**DOCUMENT 00 90 00**  
**ADDENDUM**

**ADDENDUM No.:** 1

**DATE:** October 19, 2023

**RE:** LHA 2023 CAPITAL IMPROVEMENTS  
MULTIPLE LOCATIONS – SEE DRAWINGS  
LA CROSSE, WI  
PROJECT NO. 23037

1 FIRST FLOOR REMODELED PLAN  
1/8" = 1'-0"

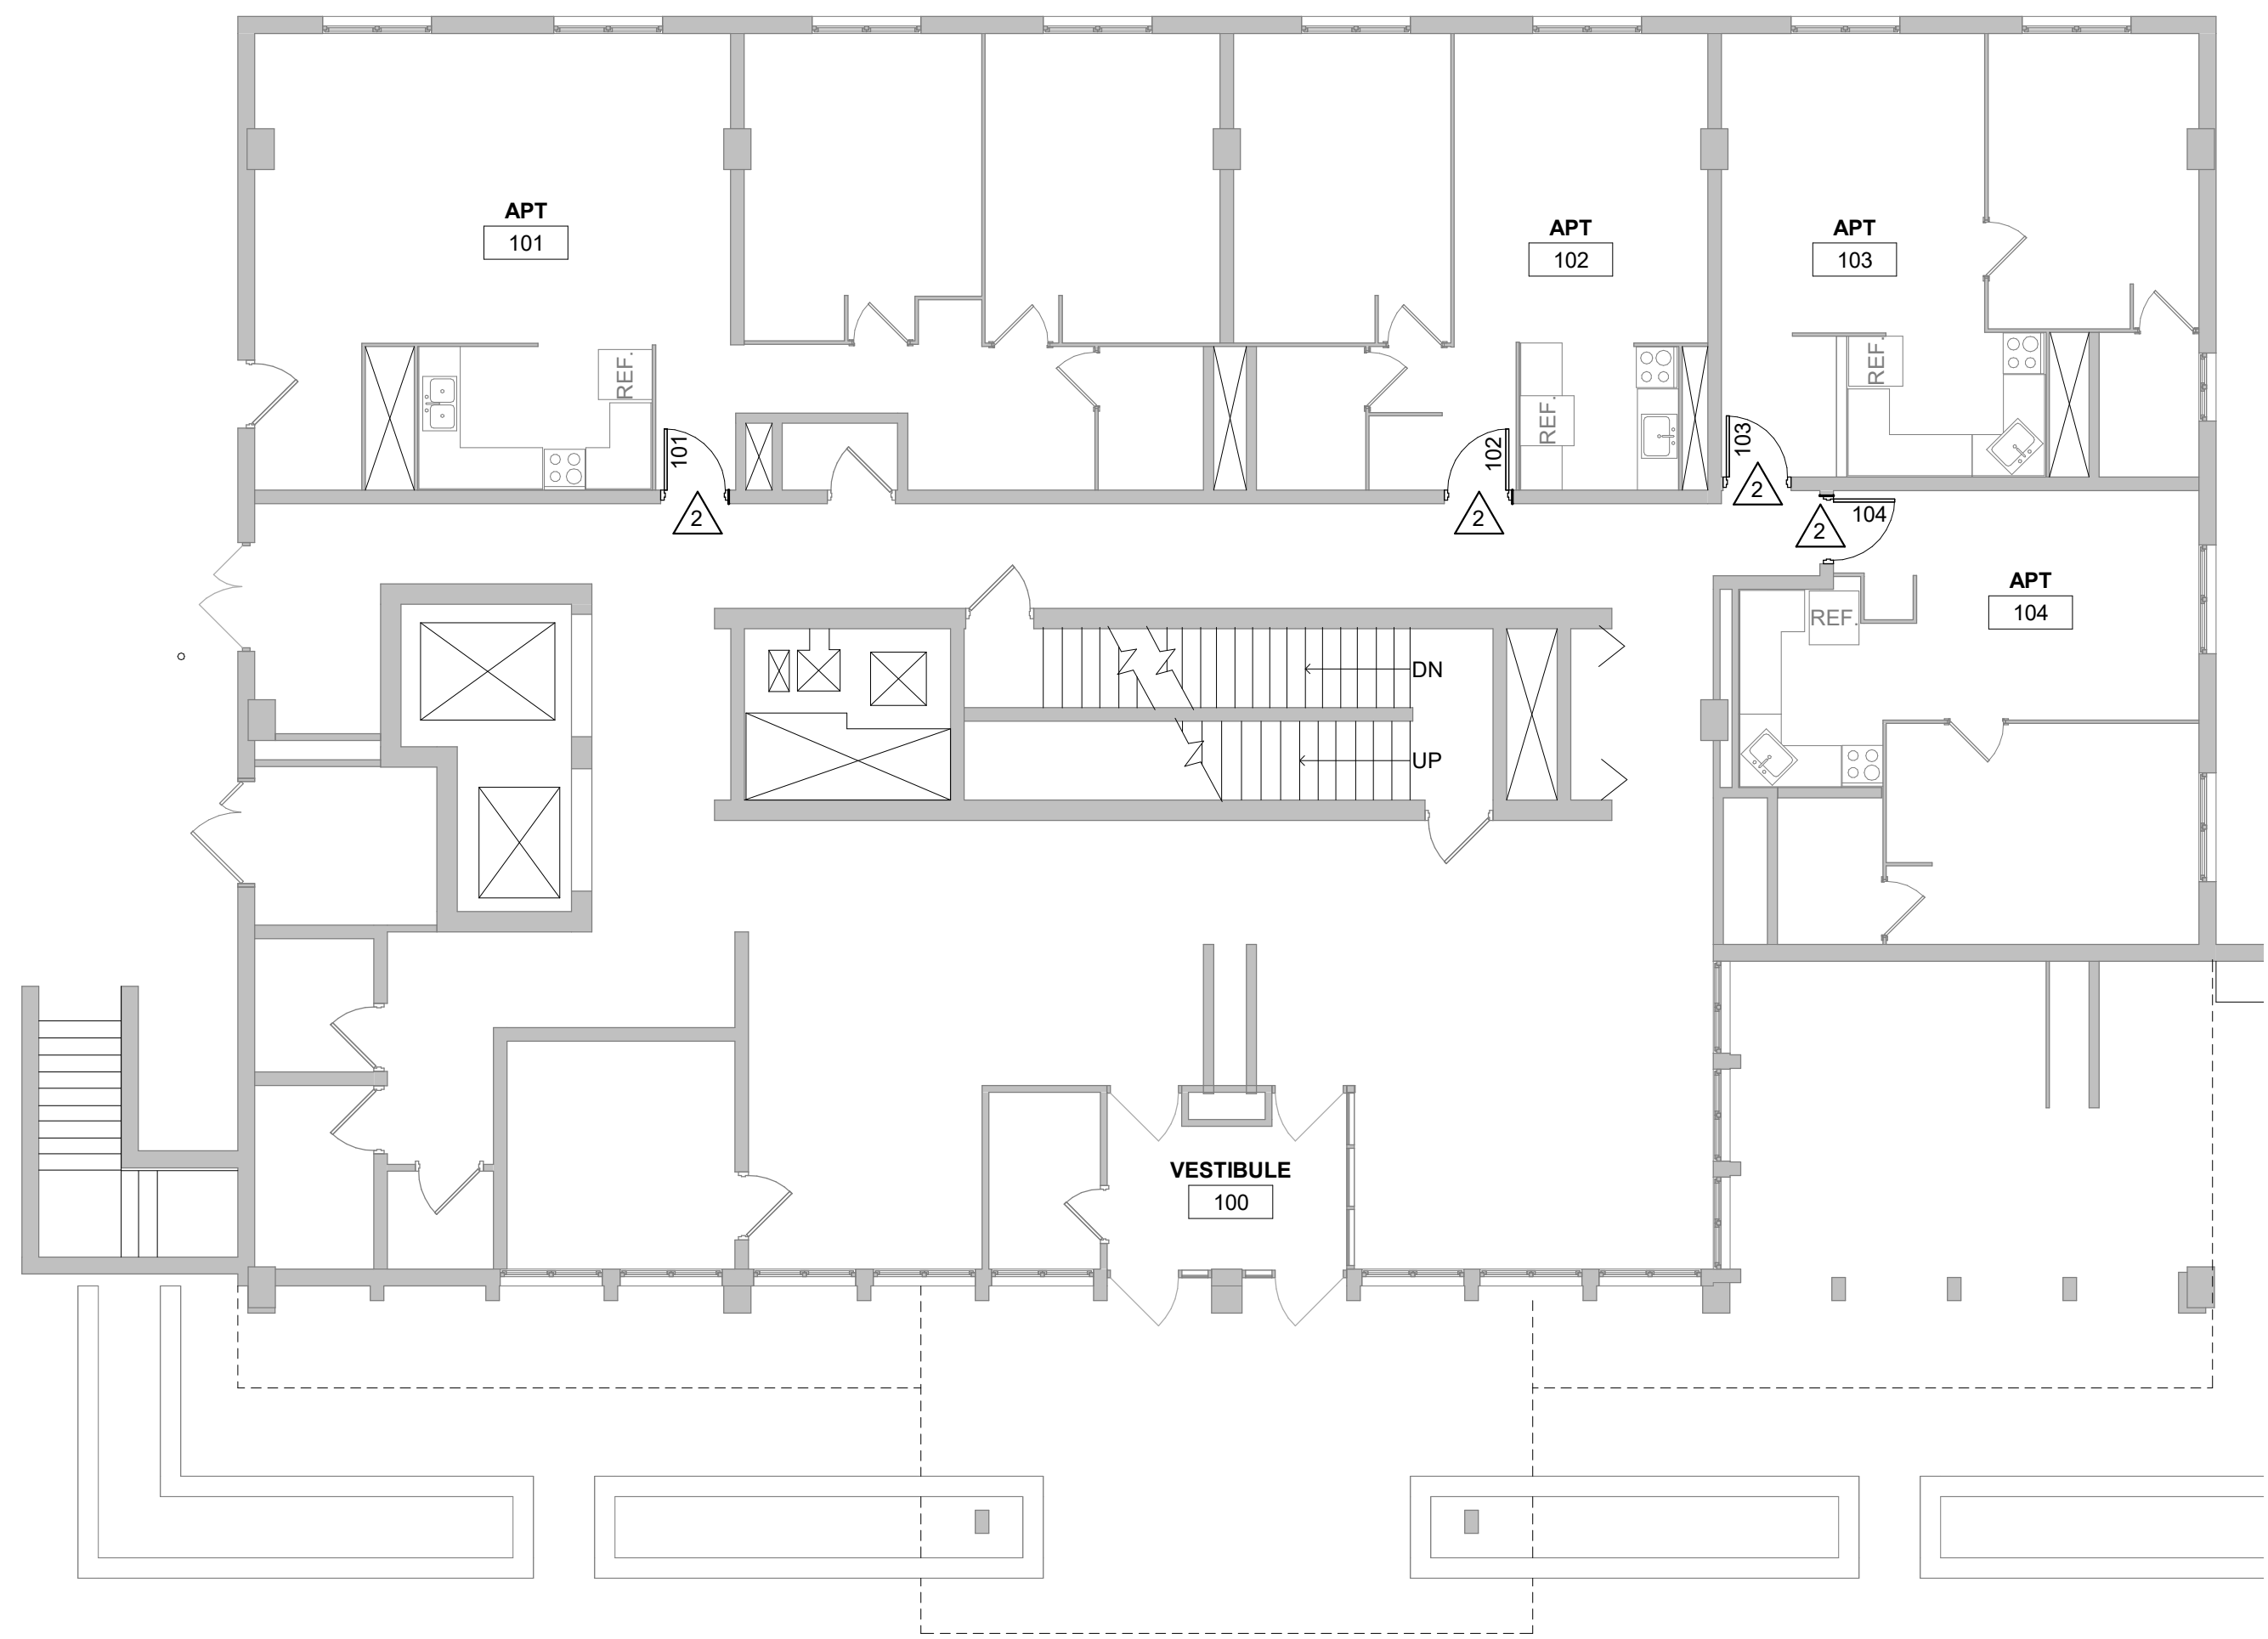
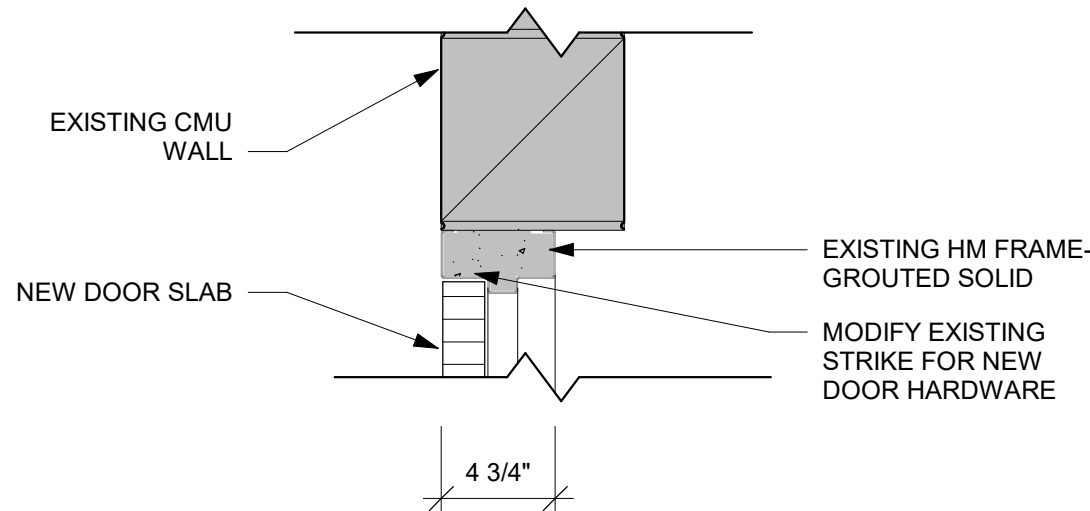
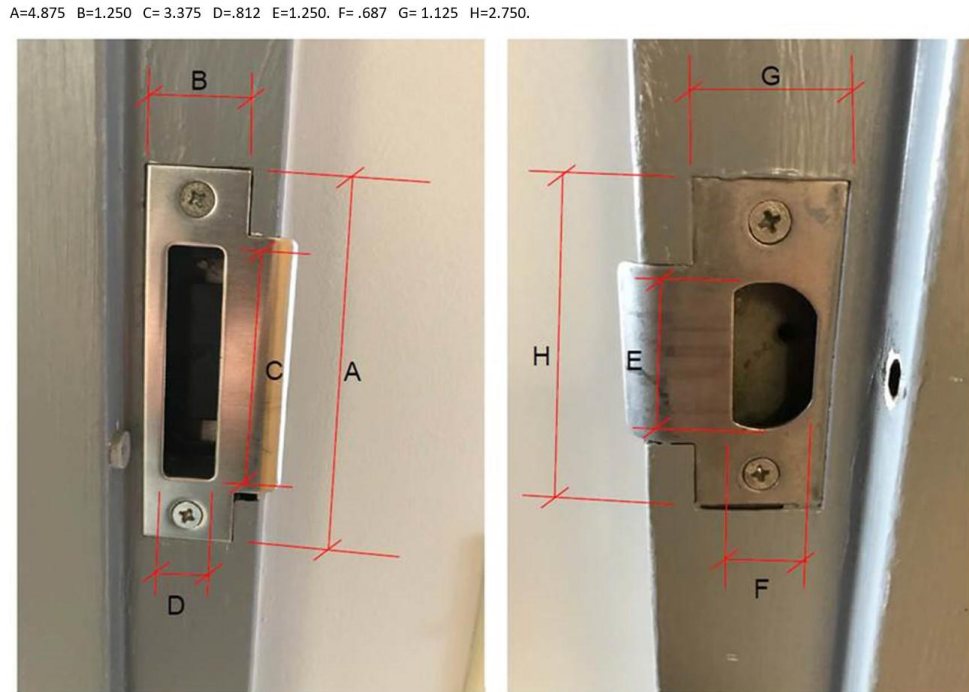
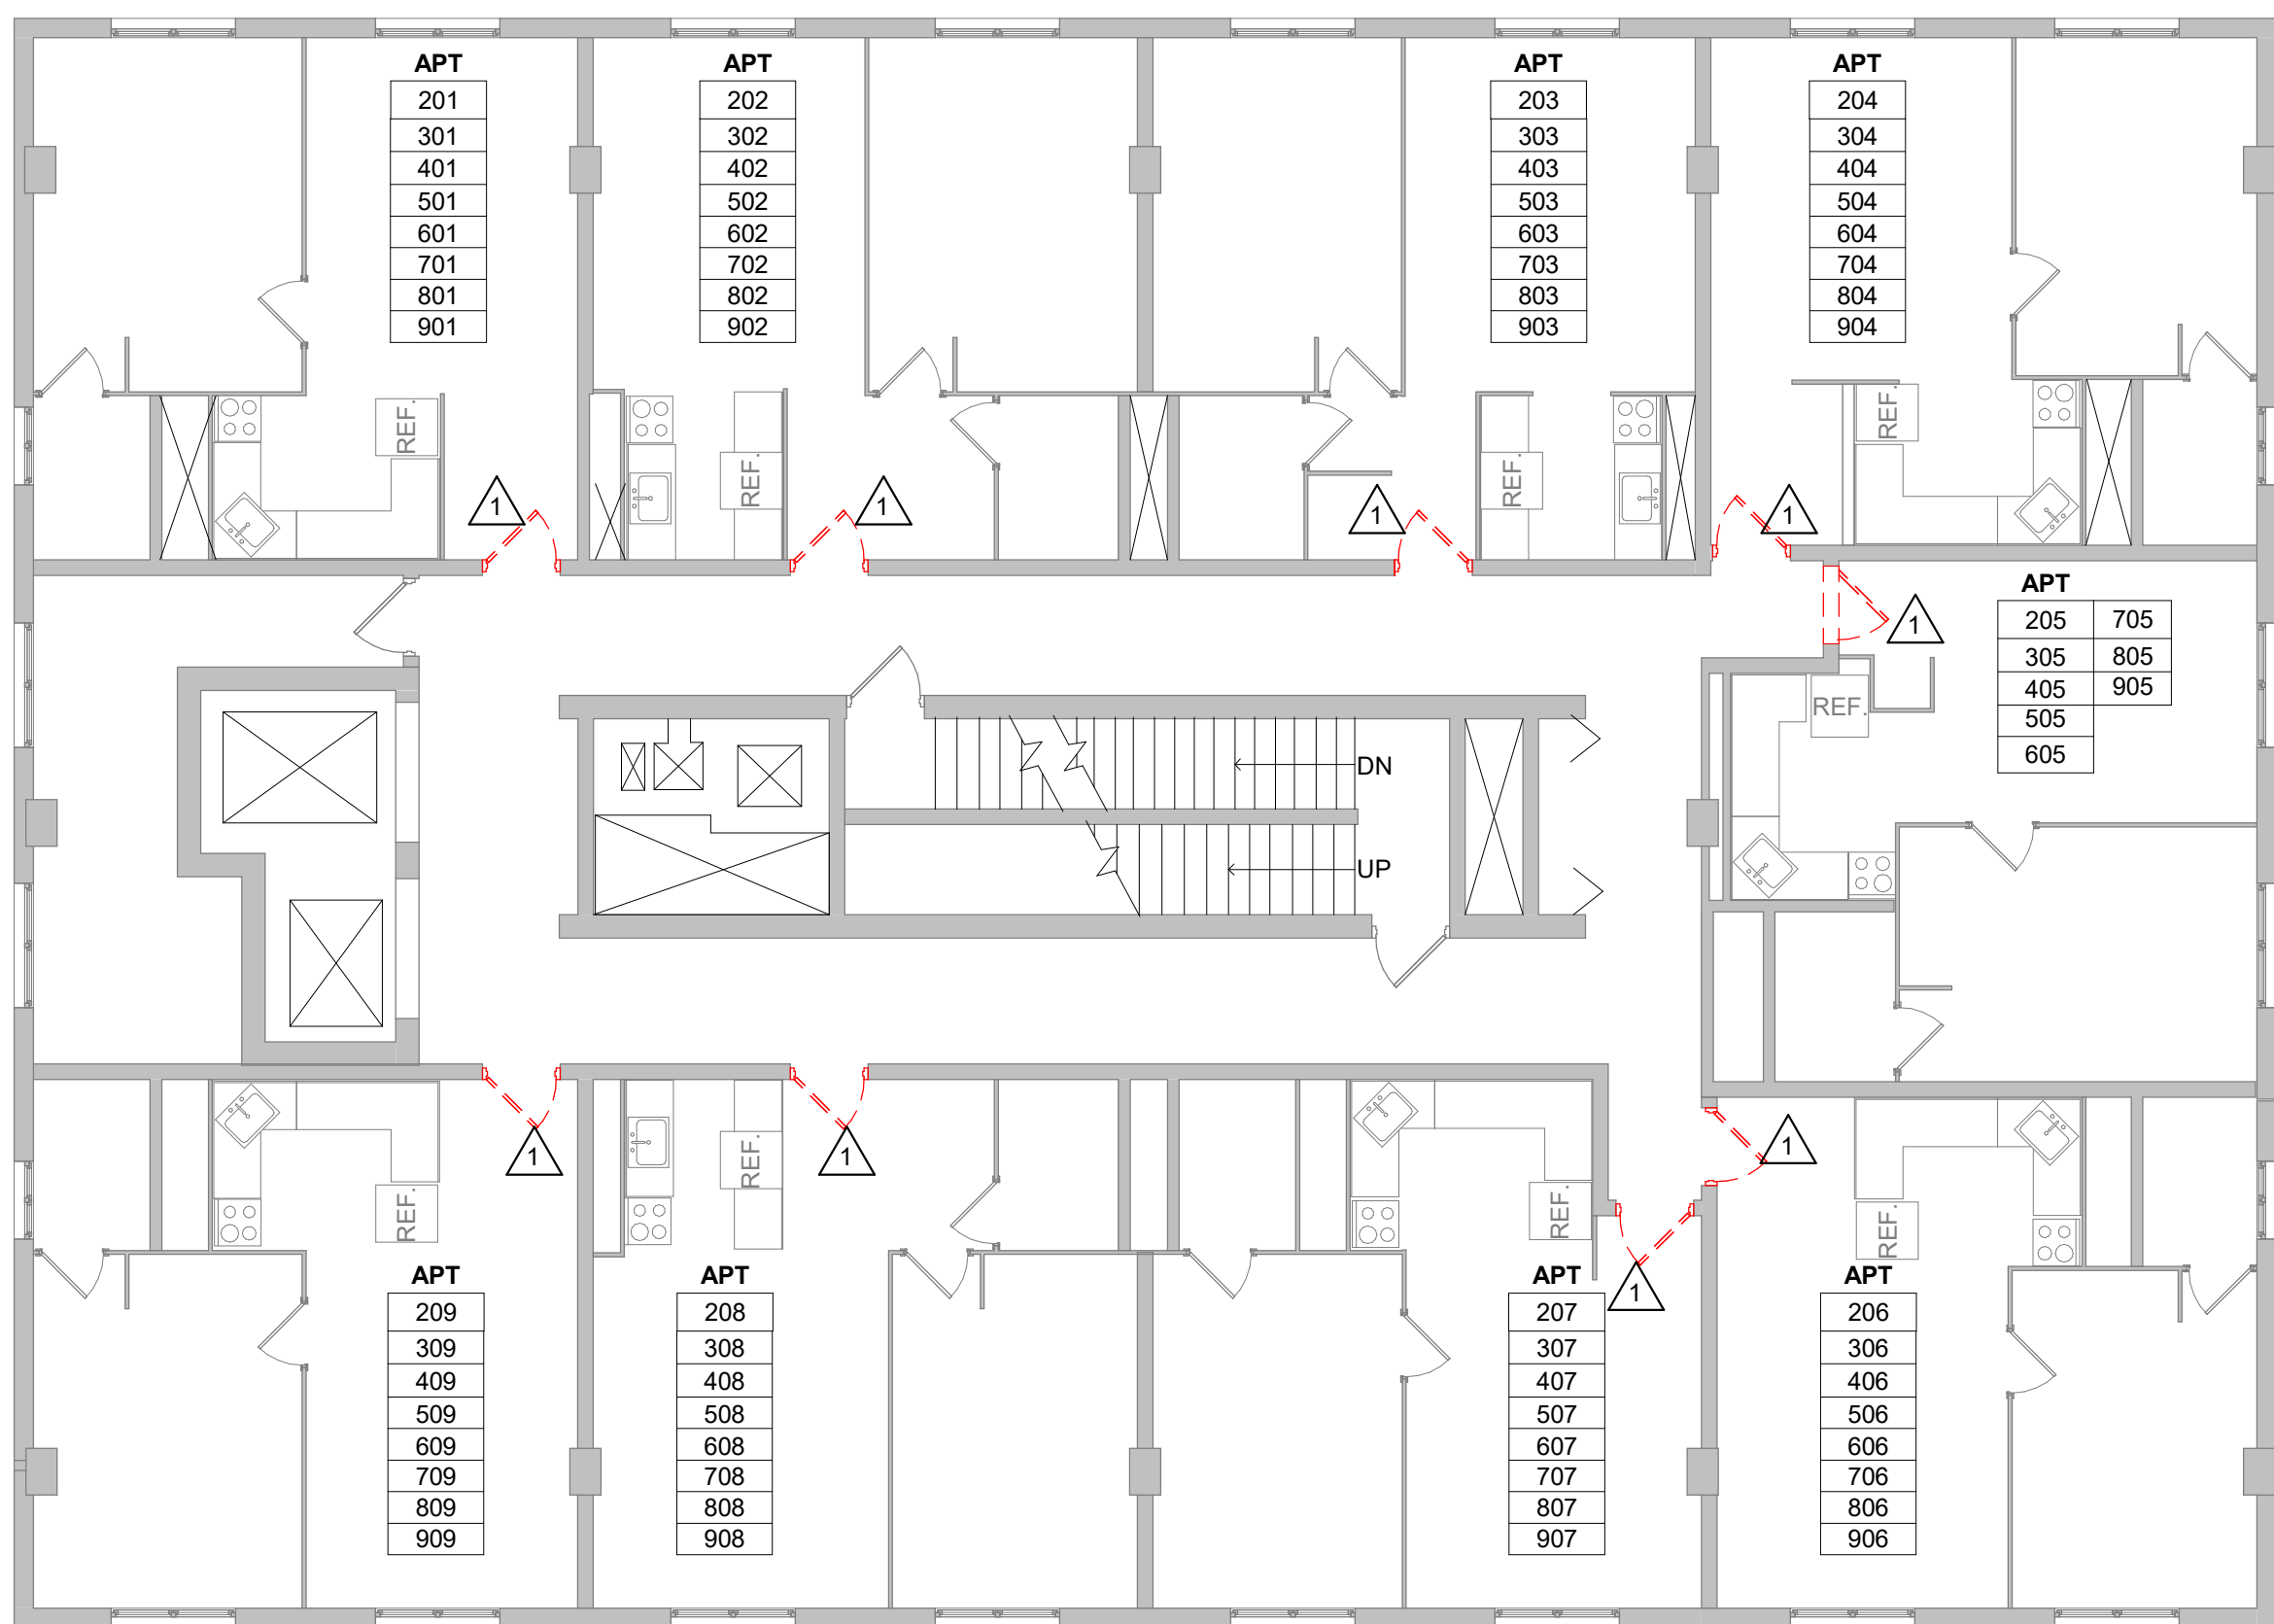
7. Sheet A100 FIRST FLOOR (STOFFEL COURT) 30"x42"
  - a. See the revised sheet included in this addendum. Disregard the previous version.
  - b. Added photos and dimensional information for door frames and hardware.

- c. Revised the door schedule.
8. Sheet A200 FLOOR PLANS (BECKER PLAZA) 30"x42"
  - a. See the revised sheet included in this addendum. Disregard the previous version.

MODIFY STRIKE FOR NEW HARDWARE. REMOVE GROUT AT STRIKE LOCATION FOR CLEARANCE OF NEW DEADBOLT. PATCH & PAINT FRAME AT LOCATION OF MODIFICATIONS TO MATCH EXISTING.

1 REMOVE EXISTING DOOR SLAB - PREPARE OPENING AS REQUIRED FOR NEW DOOR SLAB - SEE DOOR SCHEDULE.

2 INSTALL NEW DOOR SLAB IN EXISTING FRAME - MODIFY FRAME AND STRIKE AS REQUIRED FOR NEW DOOR HARDWARE. PAINT AND FILL FRAME MODIFICATION FOR CONSISTANT FINISH - SEE SPEC
